HISTORIC AND DESIGN REVIEW COMMISSION

HDRC CASE NO: 2019-018
ADDRESS: 1507 FULTON AVE
LEGAL DESCRIPTION: NCB 2756 BLK 62 LOT 15
ZONING: R-4, H
CITY COUNCIL DIST.: 1
DISTRICT: Fulton Historic District
APPLICANT: Aaron Consuelo
OWNER: Aaron Consuelo
TYPE OF WORK: Rear Addition, Historic Tax Certification
APPLICATION RECEIVED: January 15, 2019
60-DAY REVIEW: March 14, 2019

The applicant is requesting a Certificate of Appropriateness for approval to:

- 1) Construct a rear 415 sq ft addition.
- 2) Receive Historic Tax Certification.

① NORTH ELEVATION – EXISTING
SCALE: 1/4"=1'-0"

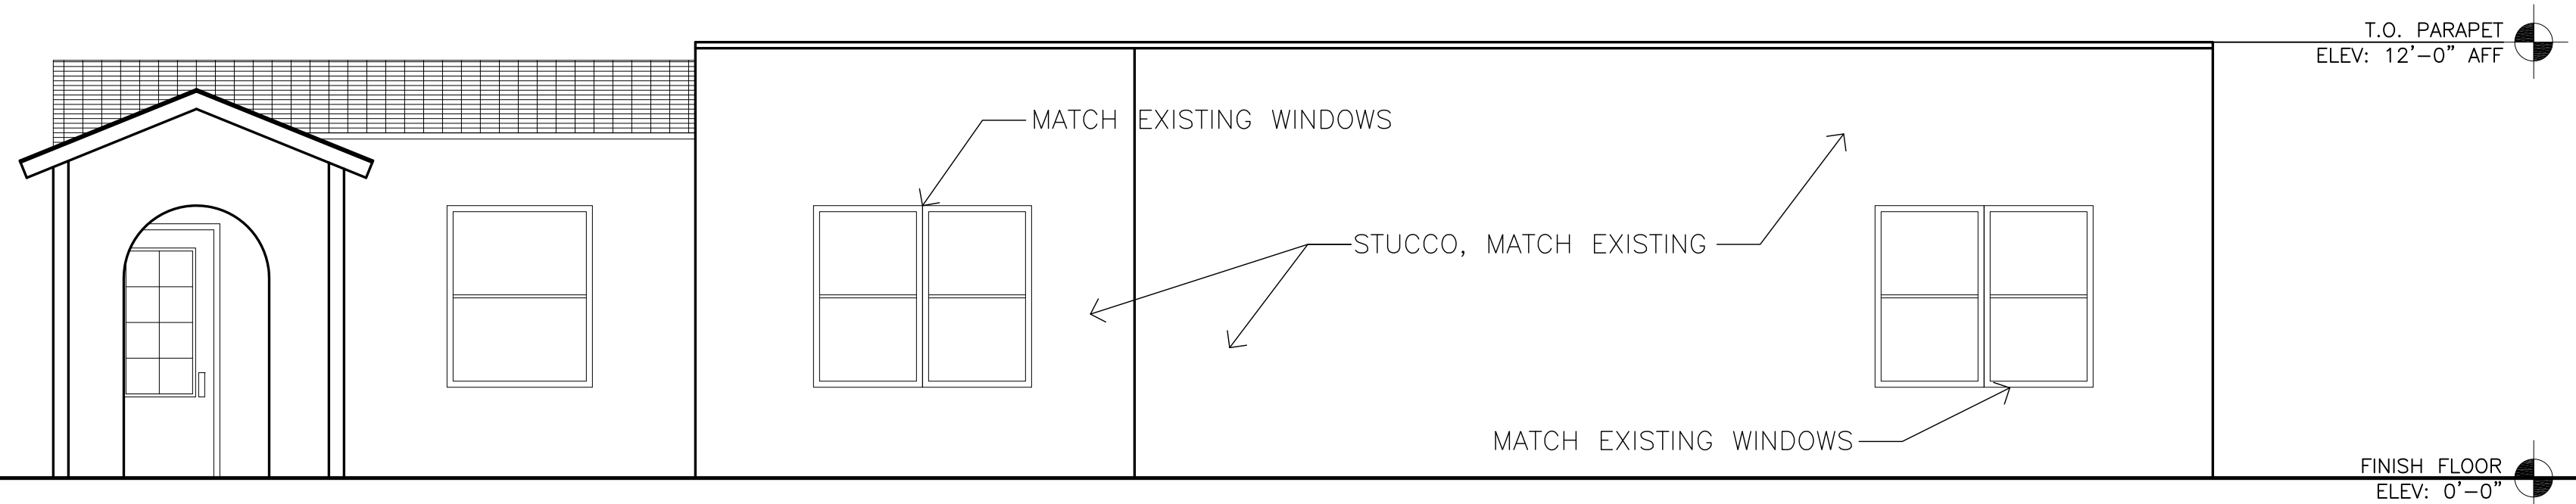
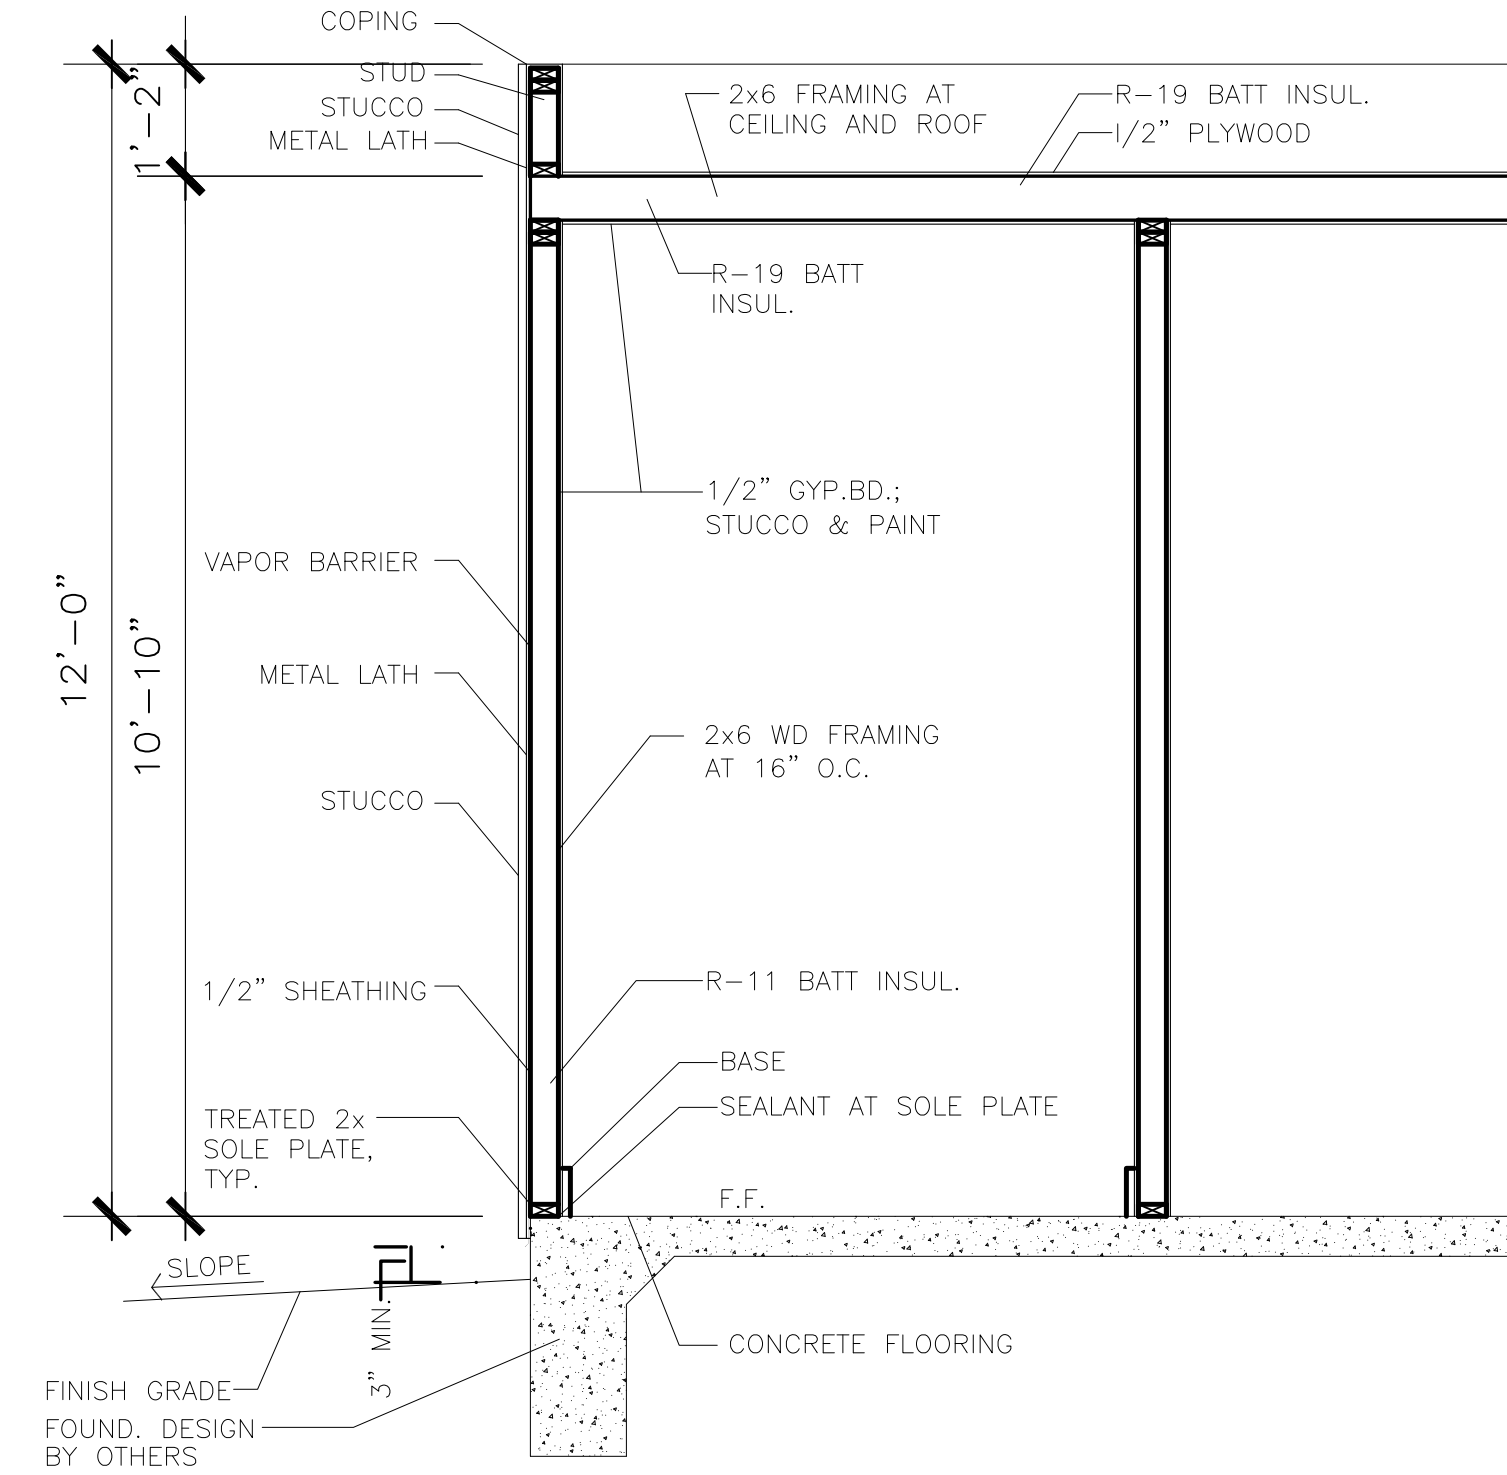
- e. TRANSITIONS – The proposed rear addition features wall planes flush with the existing wall planes and matching stucco material. Staff finds that the rear addition should feature an inset wall plane to provide a clear visual distinction between old and new building forms in accordance with the Guidelines for Additions 1.A.iv.

1. Staff recommends approval of the rear addition based on findings c through h with the following stipulations:
 - i. That the rear addition feature an inset wall plane on the side elevations to provide a clear visual distinction between old and new building forms.
